Reinforcement to the North Shropshire Electricity Distribution Network

SP Manweb's Responses to S51 Advice and Comments on the S55 Checklist

Application Reference: EN020021

Figure 1: Map of the Severn river basin district

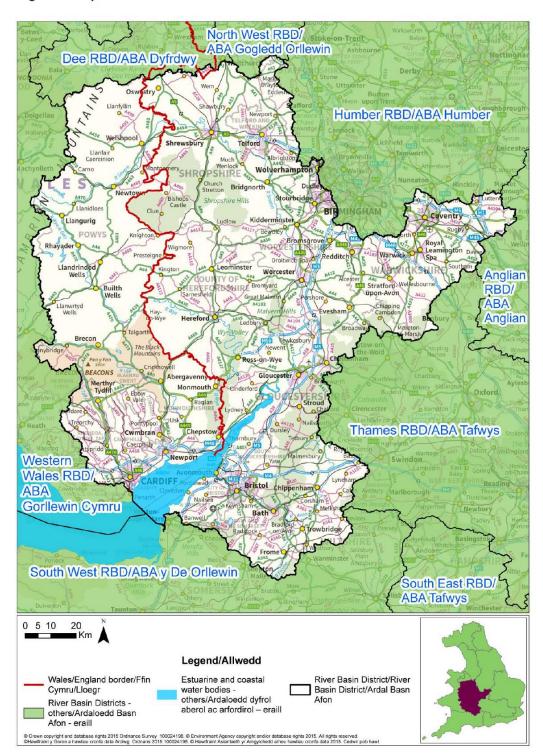
Subject Matter	Examining Authority's Comment
River Basin Management Plan	It is noted in the Checklist that a plan identifying water bodies in a river basin management plan has not been submitted. The Applicant is asked to provide this, along with clarification on whether the rivers Roden and Perry are the only relevant features in the Severn River Basin District Management Plan which could potentially be affected by the Proposed Development.

- 2.22. The Proposed Development is located in the north of the area covered by the Part 1: Severn River Basin District; River Basin Management Plan (updated December 2015). An extract showing Figure 1 from the River Basin Management Plan (RBMP) is provided below.

- 2.23. SP Manweb can clarify that the Rivers Roden and Perry are the only features mentioned in the RBMP which could potentially be affect by the Proposed Development.
